# VESTEL Service Bulletin

<b>Model:</b> All models with AK37 Chassis.	<b><u>Service</u></b> <b><u>Bulletin No:</u> 122</b>	<b>Priority</b> ( )S. All product. ( )A. Items in Customer / Dealer stock / Service return goods. ( )B. Customer stock / Units returned for Service. (X)C. Sold items returned for Service. ( )D. Only Units returned to this bulletin. ( )E. Others
<b>SUBJECT : IC 800 defect</b>		<b>DATE : August 07, 2002</b>

<b>Model:</b> 33'' and 28'' 16:9 32'' 16:9 models with AK37 Chassis.	<b><u>Service</u></b> <b><u>Bulletin No:</u> 155</b>	<b>Priority</b> ( )S. All products. ( )A. Items in Customer / Dealer stock / Service return goods. ( )B. Customer stock / Units returned for Service. (X)C. Sold items returned for Service. ( )D. Only Units returned to this bulletin. ( )E. Others
<b>SUBJECT : IMPROVEMENT ON THE RELIABILITY OF 33'' and 16:9 models</b> <b>DATE : APR 17, 2003</b>

Service  
Bulletin No: 135

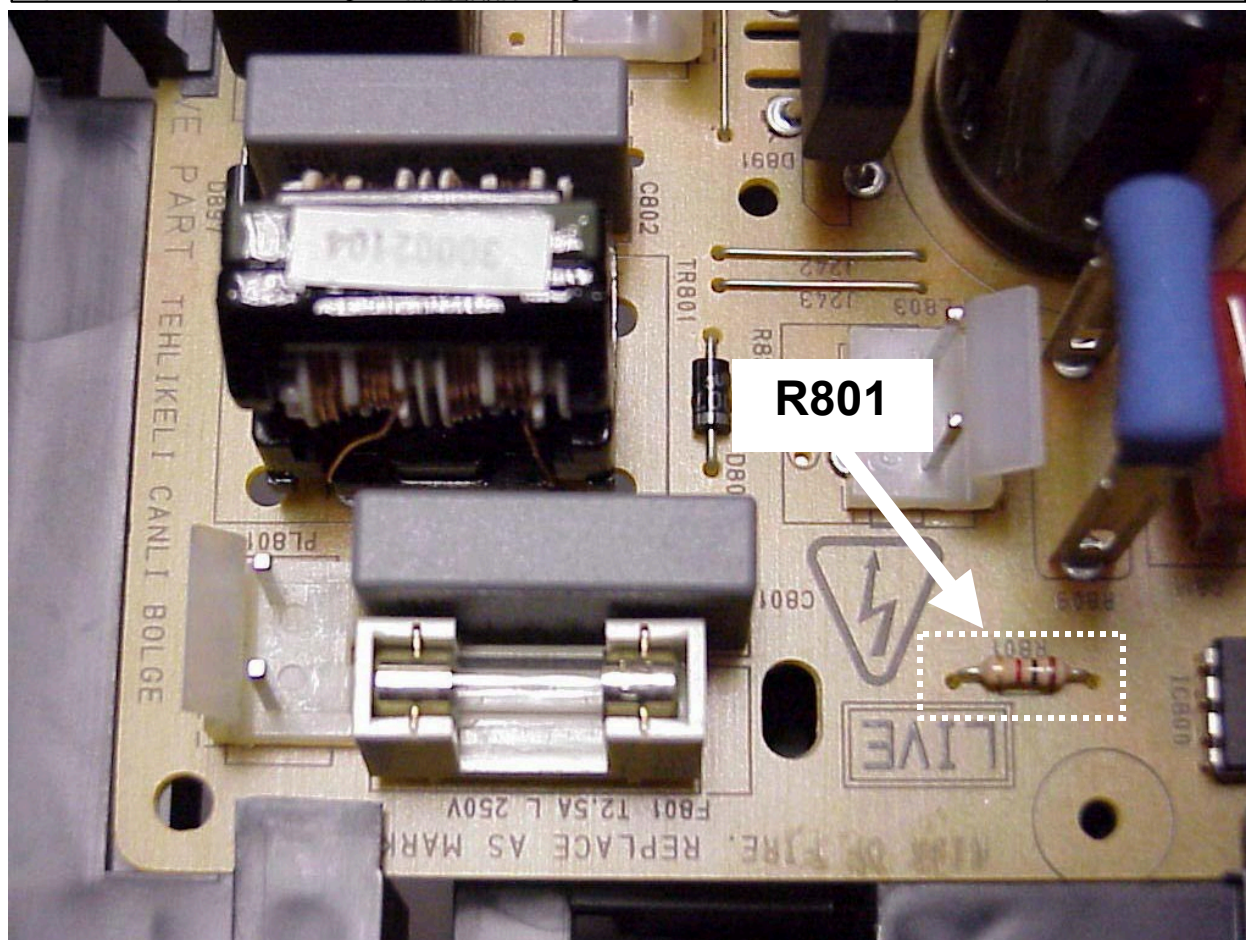
**Symptom:** Set dead.

**Cause:** Damage to IC800 has occurred due to spurious mains spikes.

**Cure:** Change the defective IC800 MC44608P (part number 30011968) and in order to improve IC800 resistance to spikes change R801 from RES CF 1/4W 1K J to RES CF 1/4W 4.7K J .

**As a preventative measure this resistor should be changed even if IC800 has not failed**

**SUBJECT : IC 601 defect****DATE : July 17, 2002****<Objective>**

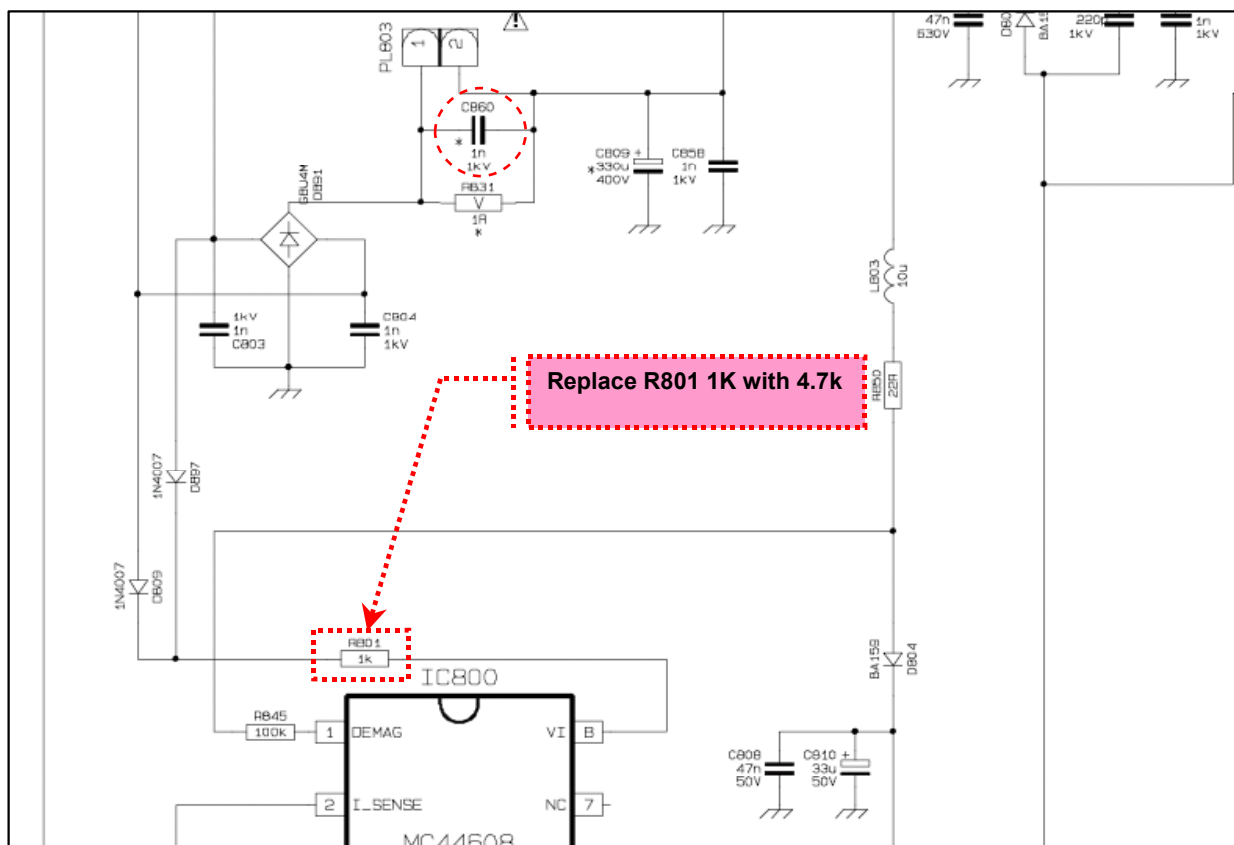
TV does not work due to IC601 broke down

Spark on CRT

1. Modify 11AK37-5, AK37-6 or AK37-7 chassis by insertion Zener diode 5.1V (VE-30007763) between pin 1 of IC601 and ground as explain below.

Solder the cathode of Zener diode 5.1V to pin 1 of IC601; solder the anode of Zener diode 5.1V to Ground

2. Insert the second zener diode 5.1V (VE-30007763) between pin 3 of IC601 and ground as explain below.

Solder the cathode of Zener diode 5.1V to pin 3 of IC601; solder the anode of Zener diode 5.1V to Ground.

3. Insert the zener diode 12V (VE-30001350) between pin 5 of IC601 and ground as explain below.

Solder the cathode of Zener diode 12V to pin 5 of IC601; solder the anode of Zener diode 12V to Ground.

4. Cut the trace between the emitter of Q603 and R606 then insert a RES CF 1/4W 560R between the emitter of Q603 and R606.
